WBN-TS-04-05

WATTS BAR NUCLEAR PLANT (WBN) UNIT 1 - TECHNICAL SPECIFICATION
(TS) CHANGE NO. 04-05 - 125 VOLT (V) DIRECT CURRENT (DC)
ELECTRICAL POWER SUBSYSTEM

TVA EVALUATION OF PROPOSED CHANGE

Diesel Generator Battery Sketch
Top View

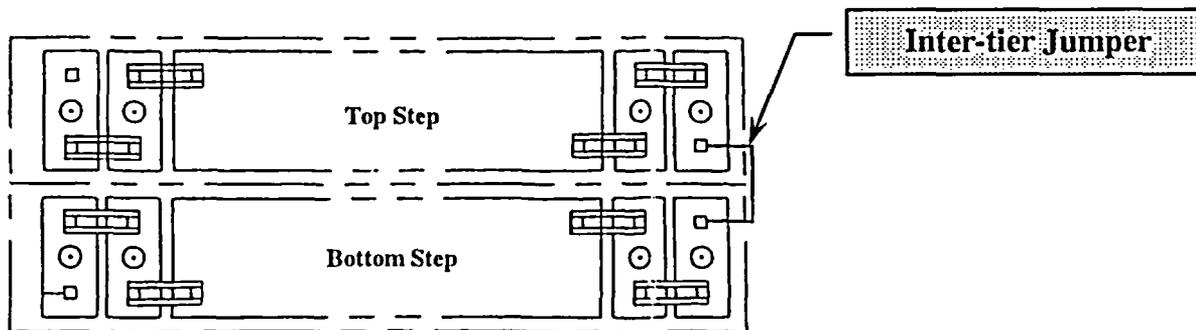
This letter is a request to amend Operating License NPF-90 for WBN Unit 1. The proposed license amendment will revise the Technical Specification (TS) to remove the term "inter-rack" and associated wording from Surveillances 3.8.4.6 and 3.8.4.10 for the 125 Volt (V) Direct Current (DC) Electrical Power Subsystems of the Emergency Diesel Generators (DGs). The TS change will clarify that the one jumper cable between battery cell tiers is the "inter-tier" jumper cable (see sketch below) by omitting all other references to inter-rack since the intent of both terms was to test the inter-tier jumper cable connections. Inter-rack is an incorrect term for the associated DG battery design.

The removal of inter-rack and associated wording will clarify the TS surveillances. To be precise, inter-rack implies that there are two or more racks per battery; however, the existing DG battery design only has one rack and testing of the inter-tier jumper cable connections was what was intended. Inter-tier will remain as-is in TS surveillances and will ensure that the interior jumper connections are checked.

The proposed change will revise TS Section 3.8.4, "DC Source-Operating," by revising Surveillance 3.8.4.6 and 3.8.4.10 to remove the phrase " $\leq 50 \text{ E-6 ohm}$ for inter-rack connections" from the listed connection resistance measurement specified therein. TVA is proposing this change to remove ambiguous wording.
